LOCAL PLAN SUB-COMMITTEE AGENDA

Report to:	LOCAL PLAN SUB-COMMITTEE
Report Title:	Nationally Significant Infrastructure Project (NSIP) – Bramford to Twinstead
Date:	17th March 2022
For:	Decision
Key Decision:	No
Decision Planner Reference Number:	N/A
Report Presented by:	Alan Massow / Mathew Wilde
Report Author:	Alan Massow / Mathew Wilde
Enquiries to:	Alan Massow / Mathew Wilde

Braintree District Council response to NG Statutory consultation
 on the Bramford to Twinstead Reinforcement Project

Figure 1 – Identification of Significant Adverse Effects

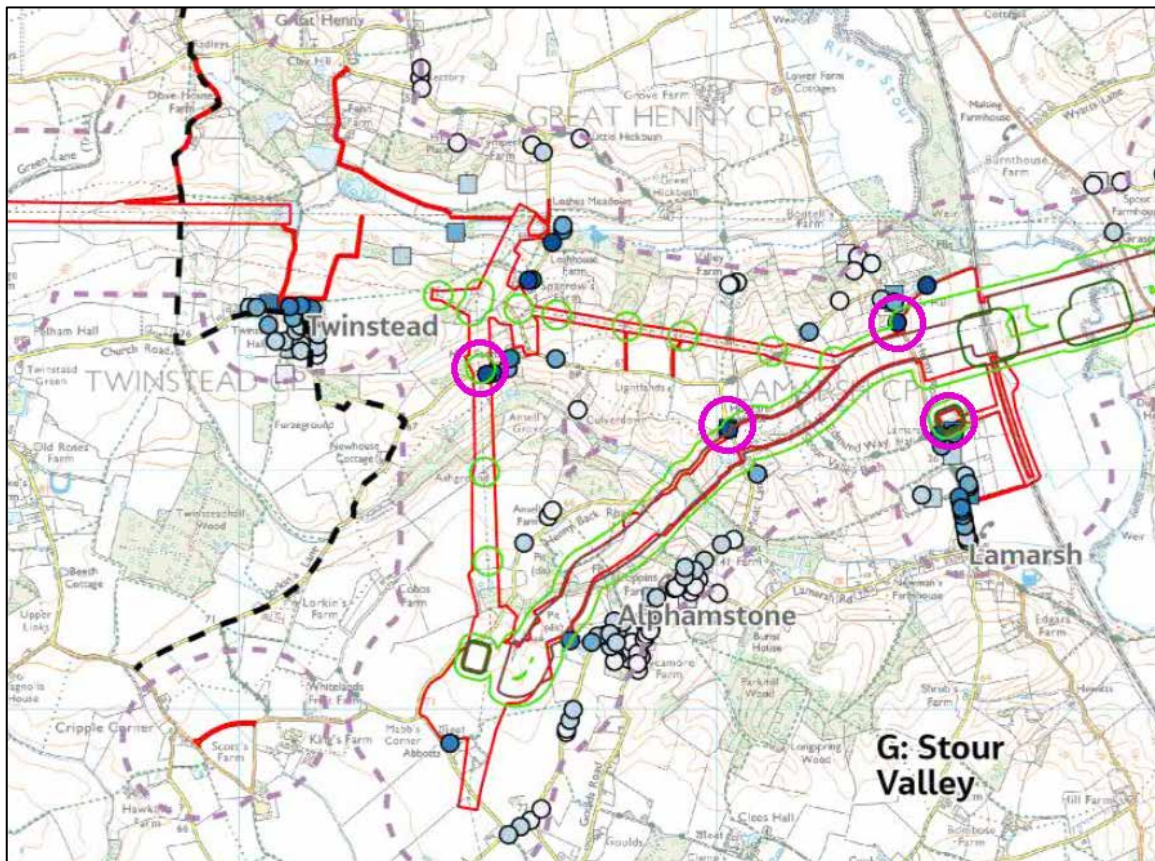
- 2.10 The effects are shown in their simplest form in the PEIR, on Page 3 of Figure 14.1. Figure 14.1 shows areas of Significant Adverse Effect in the long and short term.

- 2.11 Page 3 of Figure 14.1 identifies four areas where receptors which are likely to be significantly adversely affected by construction noise in the short-term (light green areas). Long term effects are shown as areas of dark green on the image, and no receptors are located within these areas.

- 2.12 The receptors effected by a short-term effect have been identified with pink circles in Figure 1 below.
